We hereby inform you that PCBs for illuminated and non-illuminated Navimec and Controlmec modules have been changed. All versions have been integrated into one PCB that can be adjusted according to the required design.

illuminated and non-illuminated Navimec module

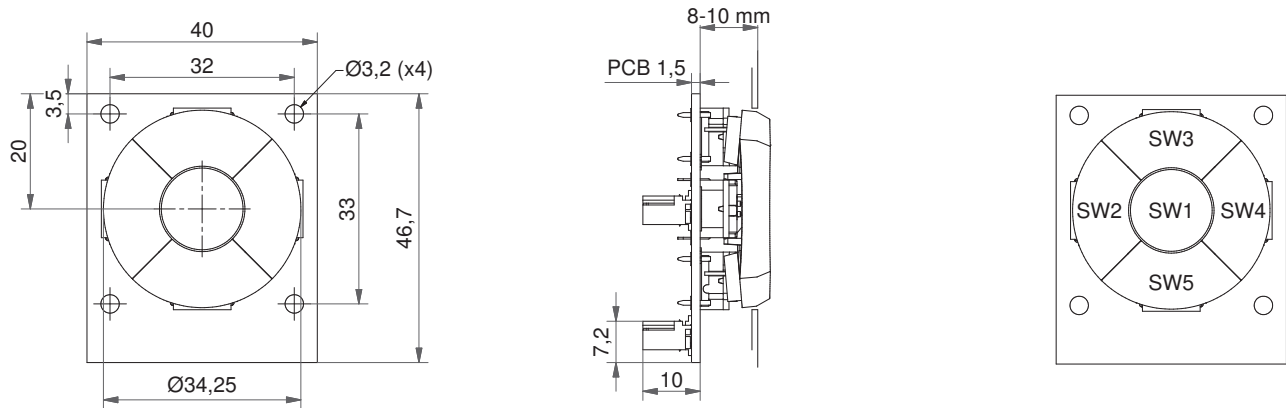
The change has already happened for the Controlmec modules. However, due to stock non-illuminated Navimec modules will be with the new PCB and connectors from 1. September and illuminated Navimec's change over will happen next year.

Circuit diagram for switches

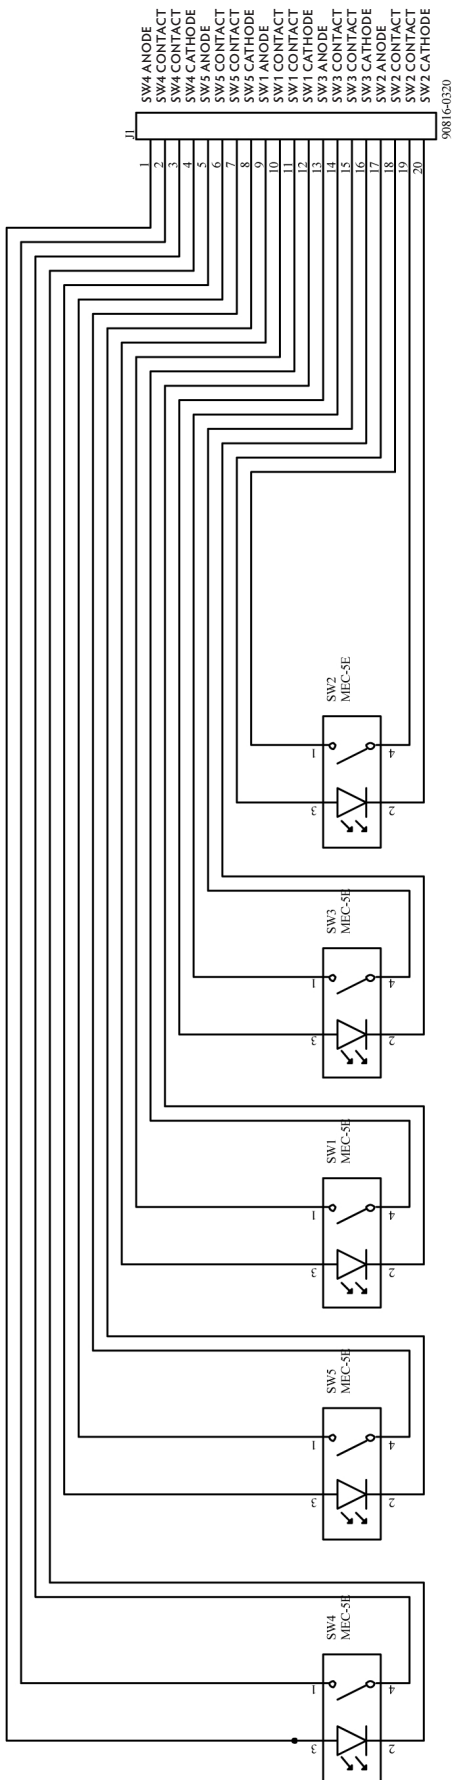
The new PCB has two connectors: upper one (J1) for switches and lower one (J2) for chip-LEDs to illuminate controlmec (see page 3 for circuit diagram and connector information).

Connectors on the module are Molex picoflex series 90816-0320 for switches and 90816-0316 for additional LEDs.

Cable socket: 90327-0320 for switches and 90327-0316 for additional LEDs
